**Written submission from
Paul Sedran, RESD Inc.**

Application to renew its McMaster Nuclear
Reactor Class IA non-power reactor operating
licence

Fitness-for-Service Review for the Control Rods
of the McMaster Nuclear Reactor

Prepared by: Paul Sedran, P.Eng
Principal, RESD Inc

Figure 1
Cross-Section of the MNR Control Rod

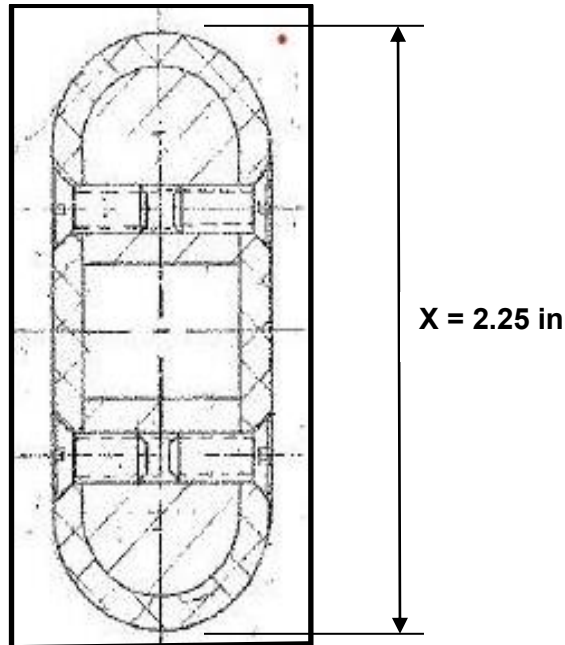
Figure 1, provided by McMaster Nuclear Operations in Reference [4], shows a cross-section of the MNR Control Rod. The absorber cross-section consists of an oval-shaped hollow shell with a transverse length, X , of 2.25 in, and a transverse width of 0.88 in. The thickness of the shell, which is made of an alloy of silver-cadmium-indium, (Ar-Cd-In), is 0.125 in.

The table provides the calculated current average fluence for the Control Rod and the resultant current percentage of swelling of the absorber element, assuming 60 years in-service. The right-hand column of the table provides an estimate of the current elongation of the cross-section of the Control Rod in the transverse direction (in the direction of X in Figure 1) that is associated with swelling of the absorber element.

**Figure 2
MNR Fuel Bundle**

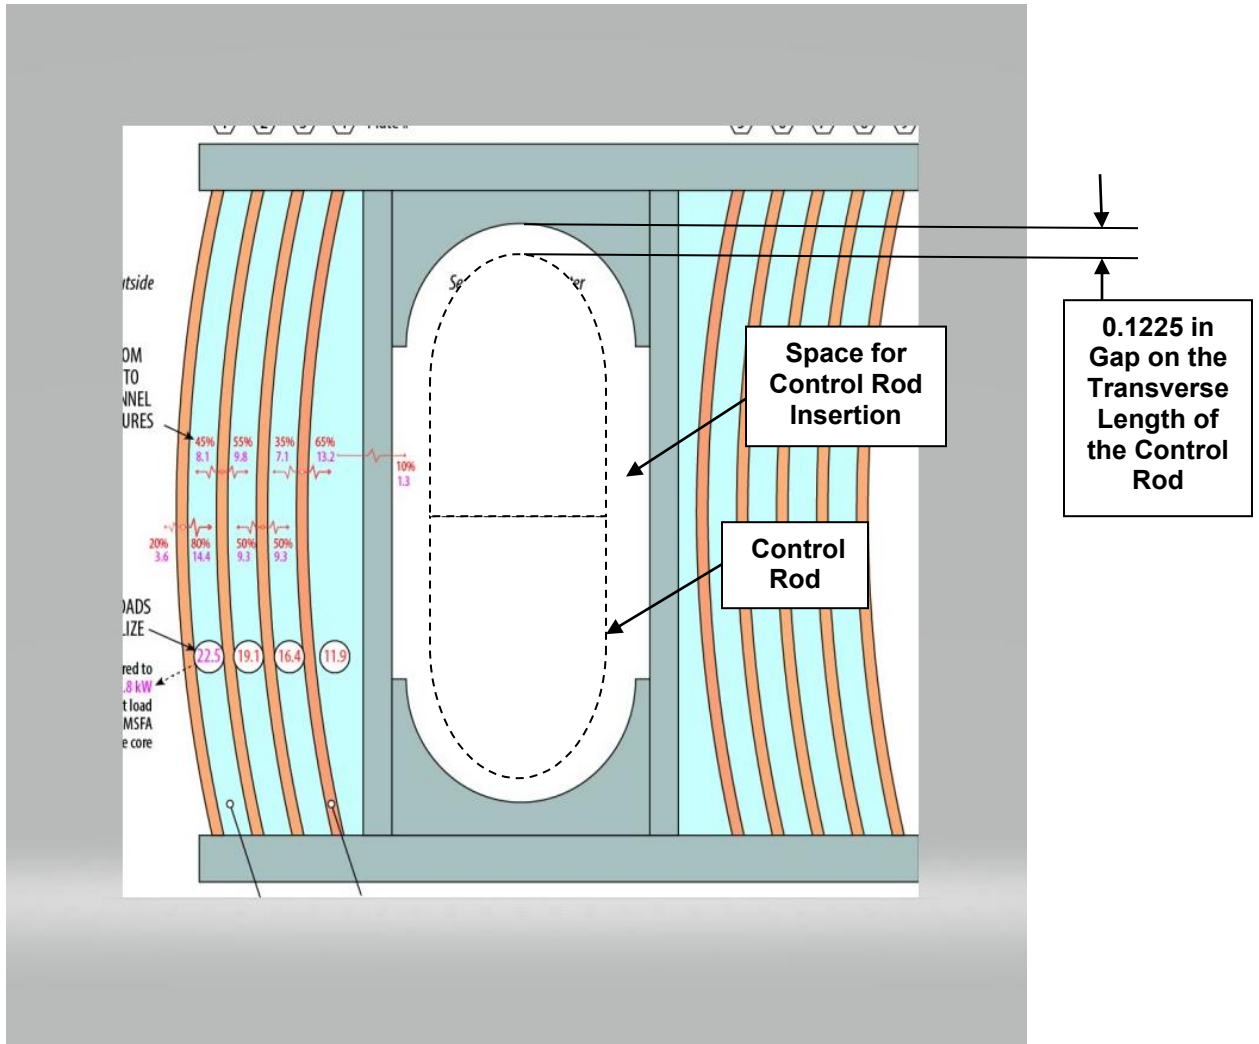
Figure 2 depicts a cross-section of a fuel bundle in MNR, noting that the Control Rod is inserted into the oval-shaped space at the centre of the Bundle.

It should also be noted that when the Control Rod is inserted into the Fuel Bundle, the nominal gap between the outside of the absorber at the maximum transverse length and the corresponding point on the Fuel Bundle is 0.1225 in. The gap in question is illustrated in Figure 2, which shows an outline of the outside of the cross-section of the Control Rod inside the Fuel Bundle.

From Table 2, the estimated current transverse elongation of the Control Rod cross-section is 0.008 inches over a nominal length of 2.25 in. Referring to Figure 2, the 0.008 inch elongation of the Control Rod cross-section means that the 0.1225 in gap with the Fuel Bundle would be reduced by 0.004 inches (only 3%) over 60 years of operation. Therefore, interference of the Control Rod with the Fuel Bundle, due to swelling, is not a concern for this assessment, or for the foreseeable future.

Figure 2
Measurements of Volumetric Swelling vs Fast Neutron Fluence
For Ar-Cd-In Absorber Material

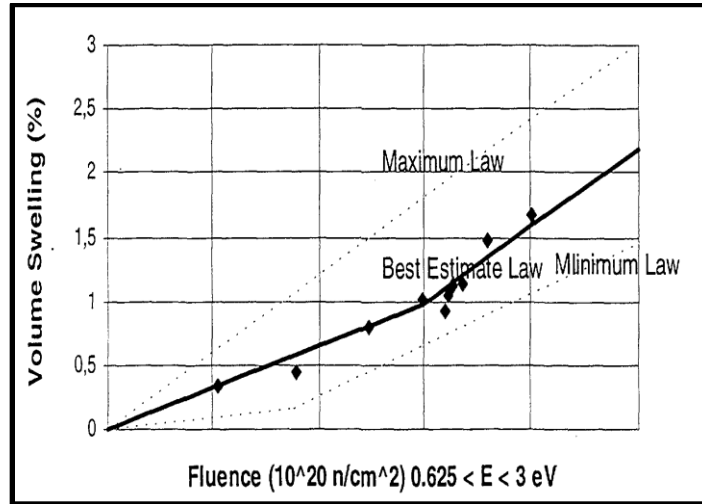
Figure 2, on the next page, from Reference [6], provides measured volumetric rates of swelling versus fast neutron fluence for Ar-Cd-In absorber material. For the swelling rate calculation, the “Maximum Law” of Figure 2 was used.

It is seen in Table 2 that the estimated current percentage increase in absorber volume of 0.045%, is a small fraction of that plotted in Figure 2, ranging from 0.4 to 1.7%.
